MFN No. 089-94
Docket No. STN 52-004

**Subject: NRC Requests for Additional Information (RAIs) on the
Simplified Boiling Water Reactor (SBWR) Design**

The Reference letter requested additional information regarding the SBWR
Isolation Condenser performance. In fulfillment of this request, GE is
submitting Attachment 1 to this letter which transmits the response to RAI
440.6.

RAI Number: 440.6

Figure A.1. Dodewaard IC Capacity

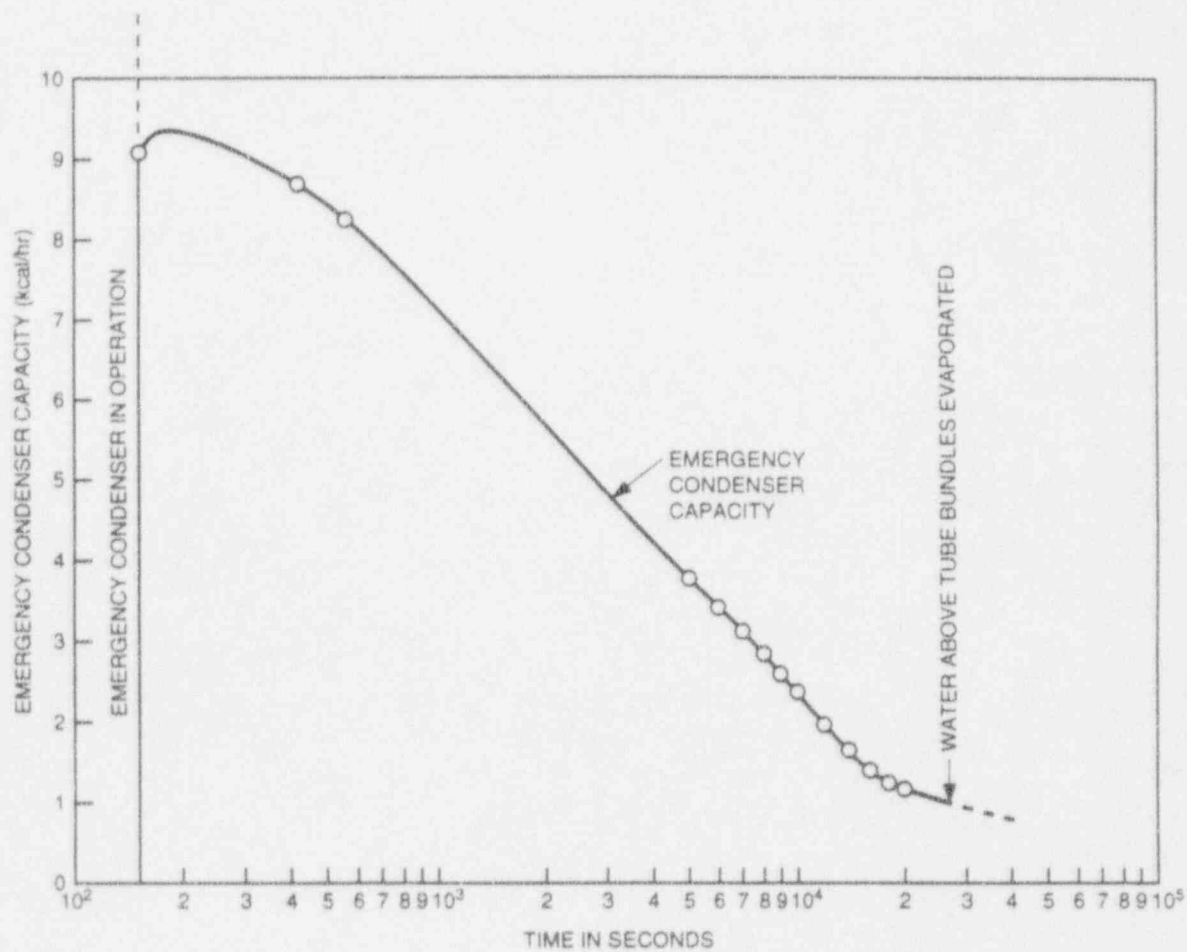
RAI SRXB.28 requested information concerning IC performance in currently operating BWRs and application of this information to assessment of IC performance for the SBWR. The staff requests that GE provide further information in this regard, to allow the staff to continue its review. Specifically, the staff requests that GE provide:

- a. Operational data for ICs in current-generation plants, demonstrating the heat removal capability of these systems for extended periods of time. This includes heat transfer performance and accumulation (and possible venting) of non-condensable gases.

Table b.1 of this response contains a listing of plants with isolation condensers. The longest recorded use of an IC was at Dodewaard. Figure a.1 shows that after eleven (11) hours the heat removal curve appeared to follow the decay heat generation rate. There was no discernible reduction in performance due to buildup of non-condensibles. Dodewaard has eight hours of coolant inventory in the IC heat exchanger, the greatest of any operating plant. Therefore, it is expected that this is the longest continuous use of an IC in service.
